RE: **PETITION NO. 1574** - The Connecticut Light and Power Company d/b/a Eversource Energy Declaratory Ruling, pursuant to Connecticut General Statutes §4-176 and §16-50k, for the Southington Substation to Cook Hill Junction Rebuild Project consisting of the replacement and reconductoring of electric transmission line structures along approximately 11.2 miles of its existing electric transmission line right-of-way shared by its existing 115-kilovolt (kV) 1690, 1208, 1355 and 1610 Lines between Southington Substation in Southington and Cook Hill Junction in Wallingford including the installation of approximately 650 feet of the 1690 Line underground at Lucchini Junction in Meriden, traversing the municipalities of Southington, Cheshire, Wallingford, and Meriden, Connecticut, and related electric transmission line and substation improvements.
Request for Project Changes.

Re: PETITION NO. 1574 - The Connecticut Light and Power Company d/b/a Eversource Energy petition for a declaratory ruling, pursuant to Connecticut General Statutes §4-176 and §16-50k, for the proposed Southington Substation to Cook Hill Junction Rebuild Project consisting of the replacement and reconductoring of el

Attachment A: Map Sheet 13 – Revised 4/30/2024

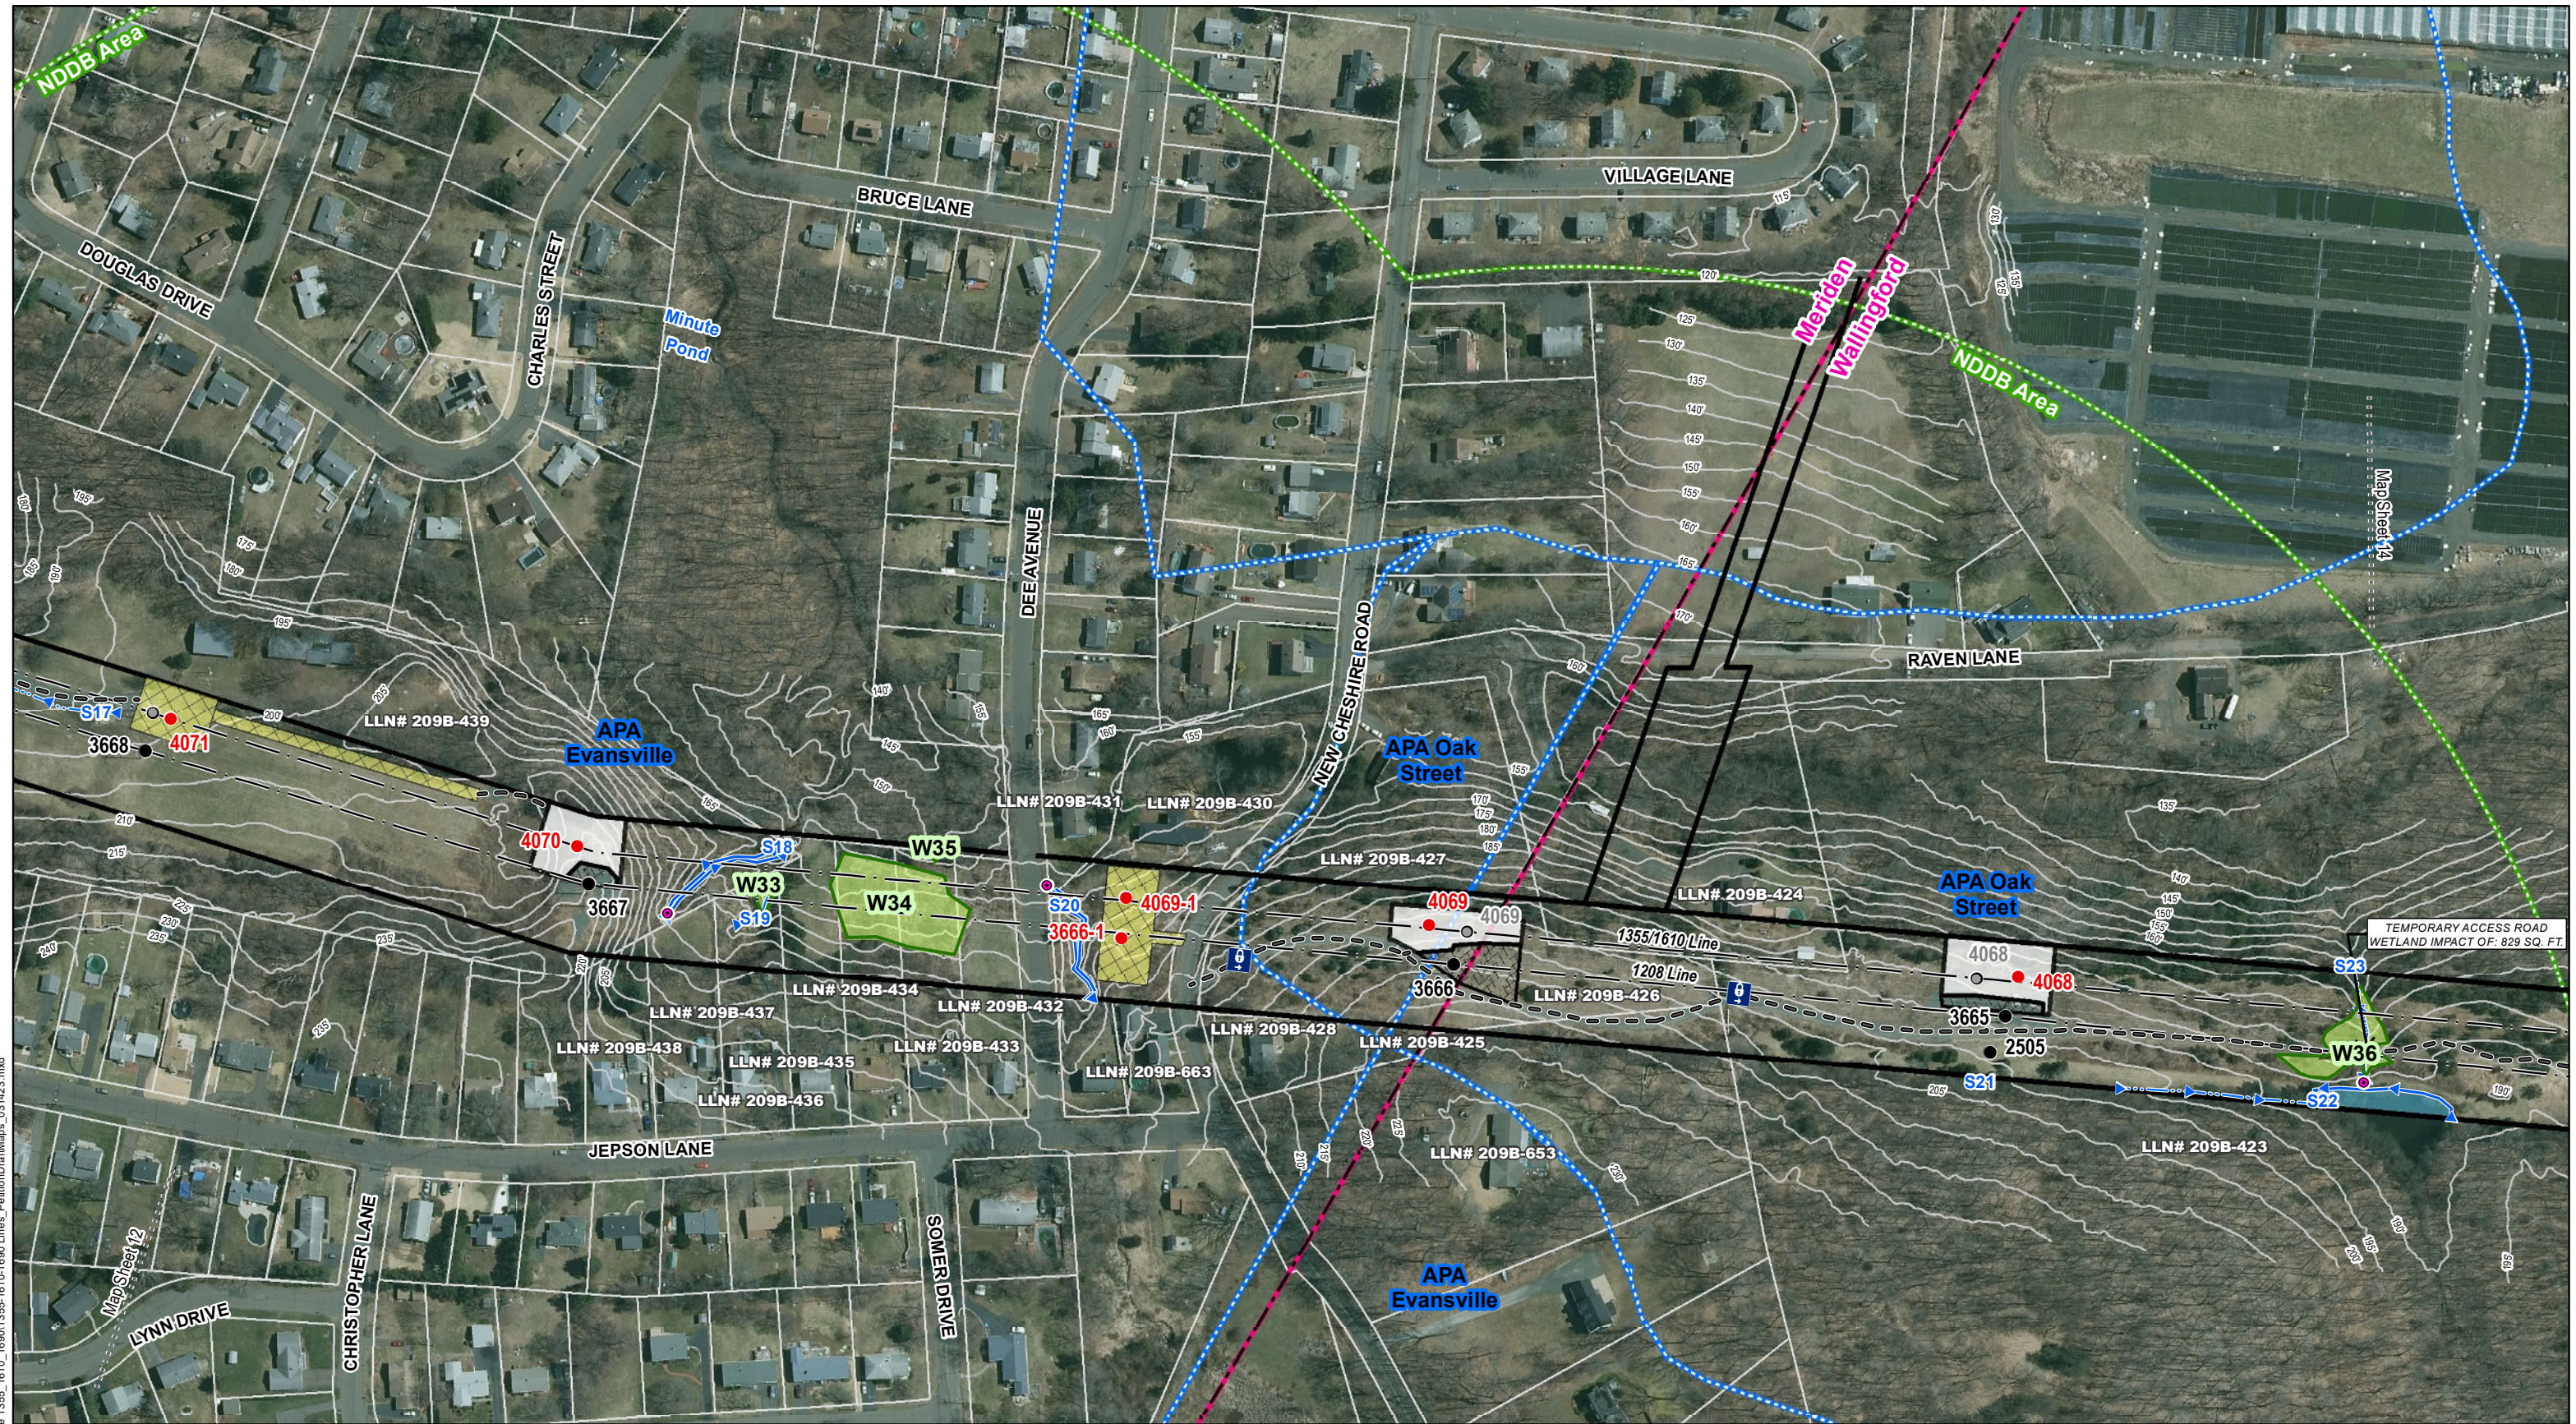
Eversource initially proposed to replace Structure 4070 twenty-five feet to the south of the existing structure. Due to the topography and safety issues, Eversource is requesting to move the structure twenty-five feet to the north of the existing structure. See Attachment A – Map-Sheet 13. The relocated structure is on the same parcel in Meriden.

Eversource is requesting to relocate the access to Structure 4069-1, by eliminating the proposed matted access road in the right-of-way off of Dee Avenue to the north and instead installing a matted access from New Cheshire Road to the south, to avoid a small stream and culvert off Dee Avenue. Access will remain in the easement. See Attachment A – Map Sheet 13.

- a) Relocate replacement Structure 4070 approximately 25 feet north of the existing structure rather than approximately 25 feet south of the existing structure; and
- b) Relocate access to Structure 4069-1 by installing matted access from New Cheshire Road to the south in lieu of installing matted access off Dee Avenue to the north.

Pursuant to Condition No. 1 of the Council's August 18, 2023 Declaratory Ruling, the specified requests for project changes are hereby approved. This approval applies only to the project changes in the correspondence dated May 9, 2024.
